Access Compliance Report

Public Rights-of-Way

(Curb Ramps)

Intersection ID: 11650	Main Street: W_10TH_ST	Cross Street: N_CHURCH_ST	Location: W
ADA ID: 64A1F49183E7	Ramp Type: PerpDiag	Initial Pass/Fail: Fail	Overall Compliance: No
Severity Score: 33.75			
Codes/Mitigation Info/Possible Solution		Field Measurements/Component Compliance

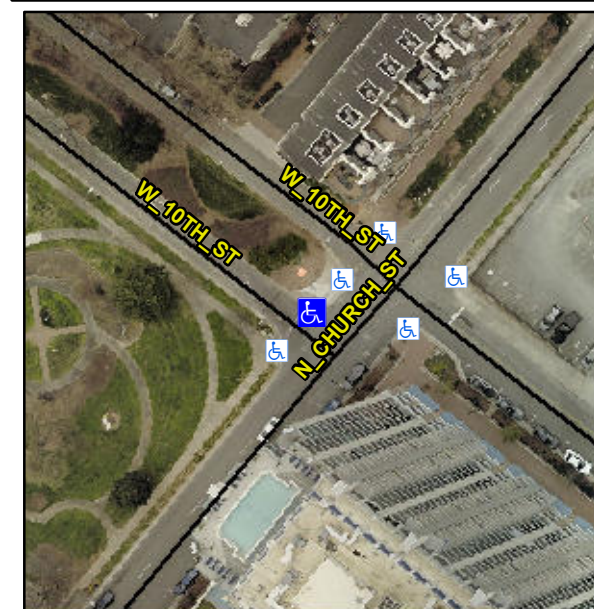
Remove & Replace Curb Ramp With Two New Directional Ramps or Equivalent.

Not Found, R304.5.1, R304.5.3

Compliance	Description	Data	Compliance	Description	Data
N/A	Ramp Length (in)	64.0	Yes	Ramp Slope (%)	5.3
No	Ramp Width (in)	38.0	No	Ramp XSlope (%)	9.1
N/A	Flare Type LT	N/A	N/A	Flare Type RT	N/A
N/A	Flare Slope LT (%)	N/A	N/A	Flare Slope RT (%)	N/A
N/A	Flare Traversable LT?	N/A	N/A	Flare Traversable RT?	N/A
N/A	Landing Length (in)	N/A	N/A	DWS Provided?	N/A
N/A	Landing Width (in)	N/A	N/A	DWS Contrast?	N/A
N/A	Landing Slope (%)	N/A	N/A	DWS Length (in)	N/A
N/A	Landing X Slope (%)	N/A	N/A	DWS Full Width?	N/A
N/A	Landing Curb? (Y/N)	N/A	N/A	DWS Offset (in)	N/A
N/A	Shared Landing?	N/A			
N/A	Gutter Ponding?	N/A	N/A	Gutter Slope (%)	N/A
N/A	Gutter Lip Ht (in)	N/A	N/A	Gutter X Slope (%)	N/A
N/A	Painted X Walk1?	No	N/A	Painted X Walk2?	No
	X Walk 1 Direction	To SW		X Walk 2 Direction	To SE
N/A	X Walk 1 Width (in)	N/A	N/A	X Walk 2 Width (in)	N/A
	X Walk 1 Slope (%)	0.7		X Walk 2 Slope (%)	0.7
	X Walk 1 X Slope (%)	1.3		X Walk 2 X Slope (%)	1.2
